SIB 12 04 26

DELIVERY STOP: HARNESS ROUTING

2026-03-26

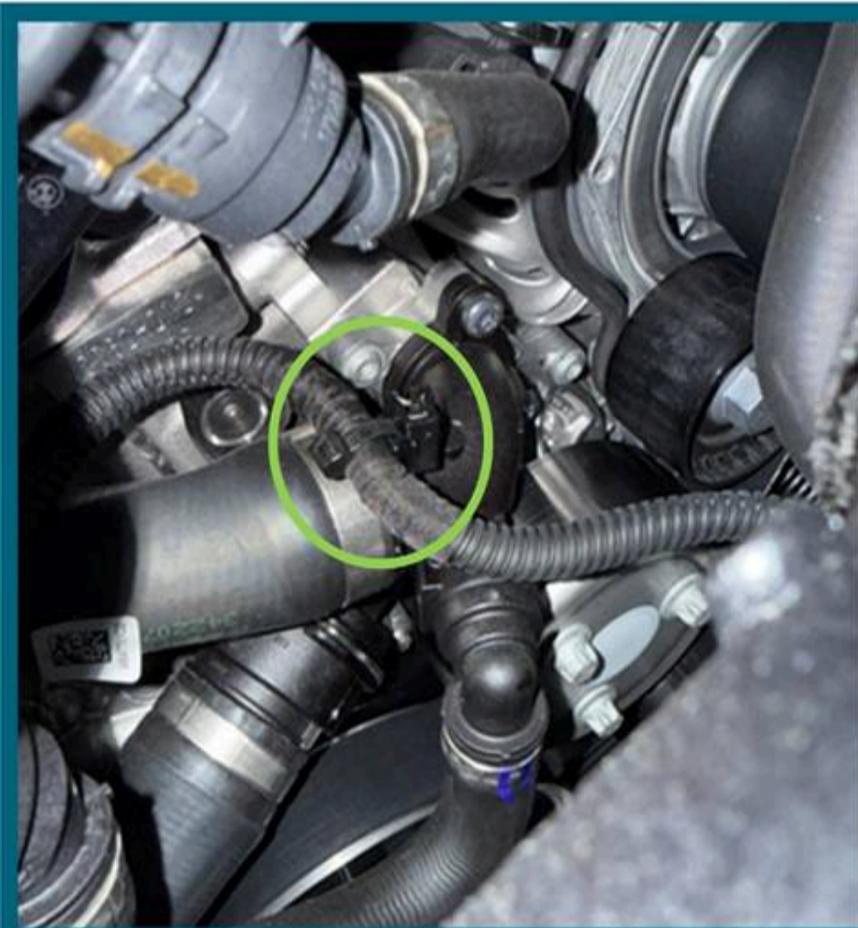
During assembly, a clip on the wiring harness for the electric water pump was misaligned.

As a result of the misaligned clip, the wiring harness for the electric coolant pump may come into contact with the belt tensioner and thereby be damaged or even severed.

Consequence: Cooling system failure with a CCM warning (or emergency mode if the LIN bus is also affected).

Check the wiring harness (Engine Sensor 2 wiring harness) in the area of the belt tensioner for damage and correct the routing. If the Engine Sensor 2 wiring harness is damaged, it must be replaced.

Alligator clip installed correctly.

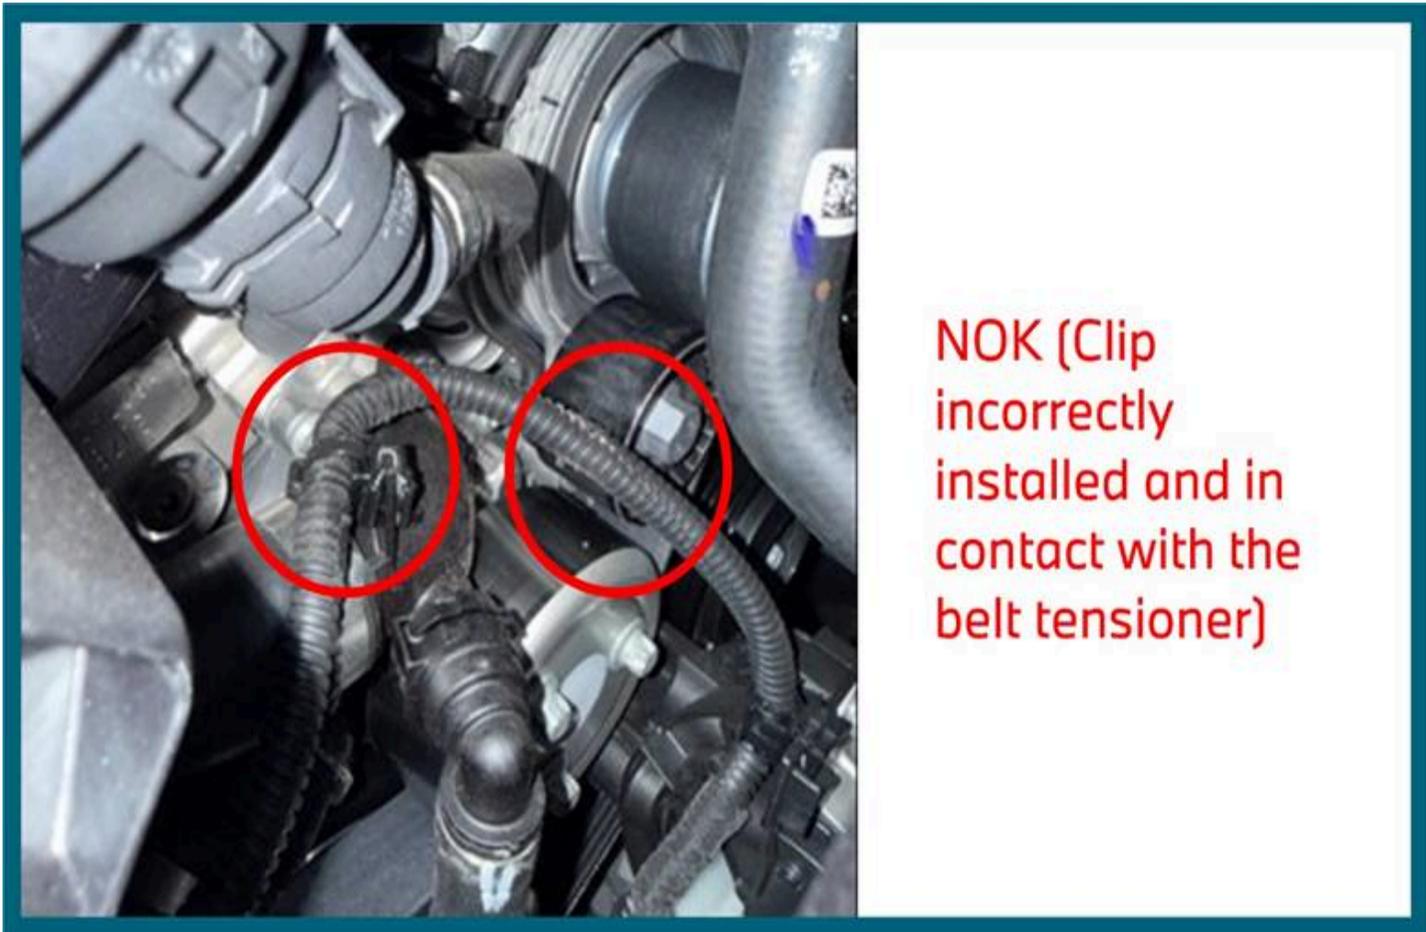
Check the positioning of the clip and inspect the harness for damage. See example photos below.

If **no** damage to the wiring harness is found, only the alligator clip needs to be corrected.

If visible damage to the wiring harness is present, the Motor Sensor 2 wiring harness must be replaced in accordance with RA12 51 240 “Motor Sensor 2 Wiring Harness”.
